TECHNICAL SERVICE BULLETIN

Bulletin Number: S-06-10

SUBJECT: 2007 FS / FST Oil Pump Elbow Nozzle Fastener Torque

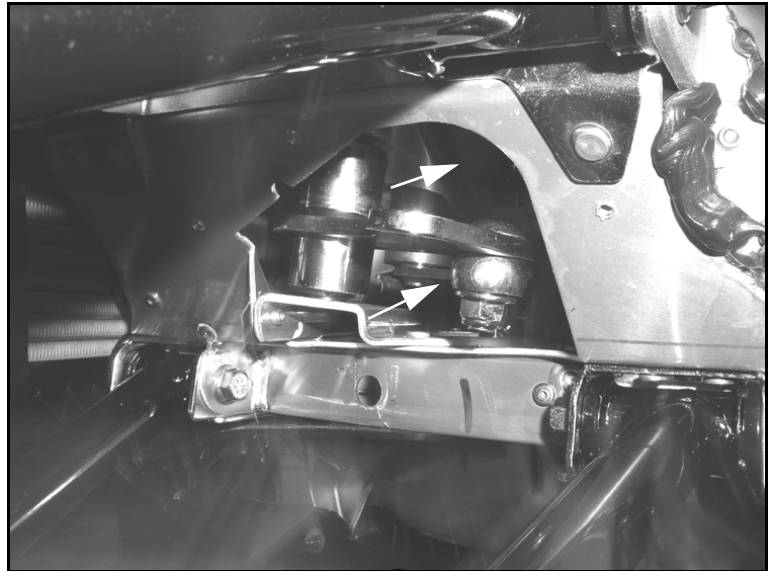
5. To enhance socket accessibility, remove the idler arm center bolt using a magnet, 9/16" socket w/ extensions and 9/16" wrench.

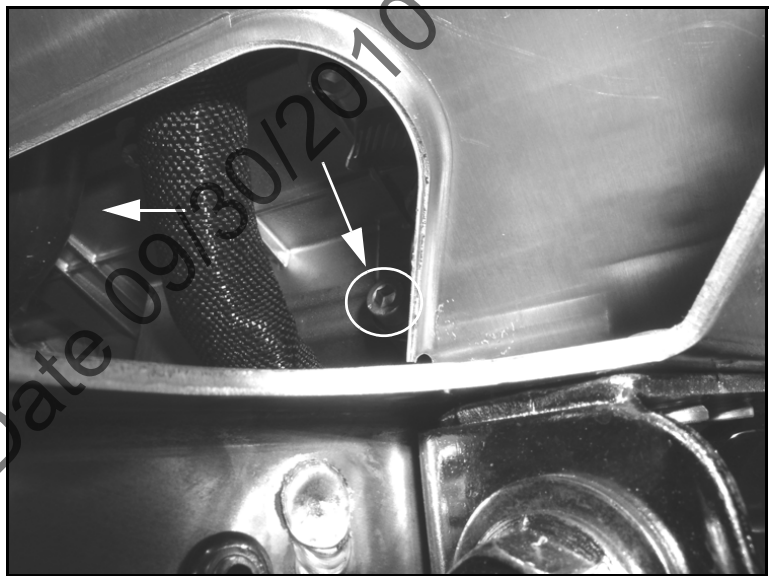
6. Fold the idler arm back into the engine compartment to increase access to the bulkhead.
